ANALYSIS AND FINDINGS LAM RESEARCH CAMPUS

ARB Hearing: September 10, 2025

Case #:	AR 24-0002
Project:	Lam Research Corporation Campus
Location:	11155-11361 SW Leveton Drive; Tax Lots: 2S122AA 500 and 800; 2S122AB 100
Representative:	Mackenzie
Owner:	Lam Research Corporation

Figure 2: Site Plan (overview, dark gray and blue areas are locations where new development is proposed)

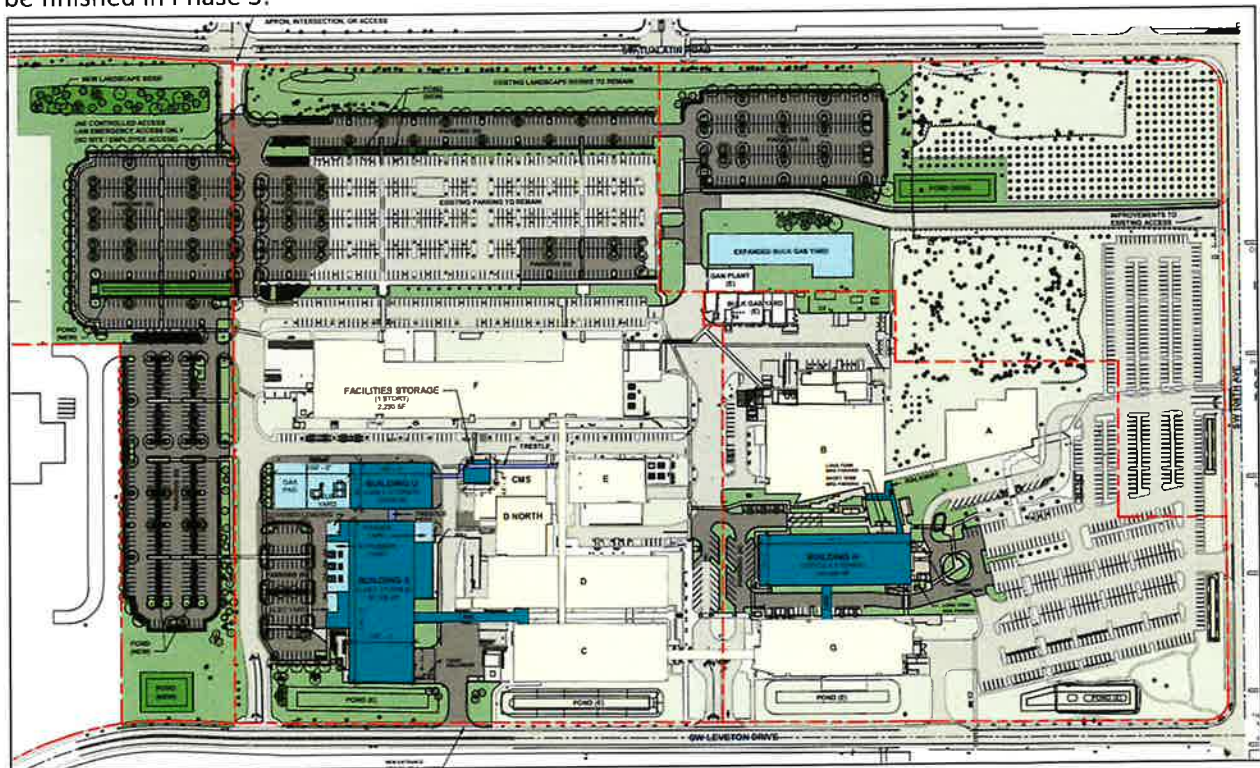
The current proposal includes construction of a new office building (120,000 square feet), lab (90,000 square feet), central utilities building (29,000 square feet), and storage building (2,230 square feet) on the southern portion of the campus adjacent to SW Leveton Drive. There will be parking areas located on the northern portion of the site with all employee traffic being directed to three existing driveways

on SW 108th Avenue and three existing driveways; one new driveway on SW Leveton Drive is proposed for truck-only traffic. Along SW Tualatin Road, the existing landscape berm is proposed to be extended to the west to provide additional voluntary buffering of the site. The applicant proposes a net increase of 544 parking spaces. This consists of demolishing 468 existing spaces to accommodate the proposed new buildings and constructing 1,012 new or replaced parking spaces. Included in the 544 new spaces are 127 spaces that were previously approved for Building “G” through AR 22-0006 but not constructed (later removed through an approved modification). In addition, associated landscaped and hardscaped areas as well as new stormwater detention ponds are proposed.
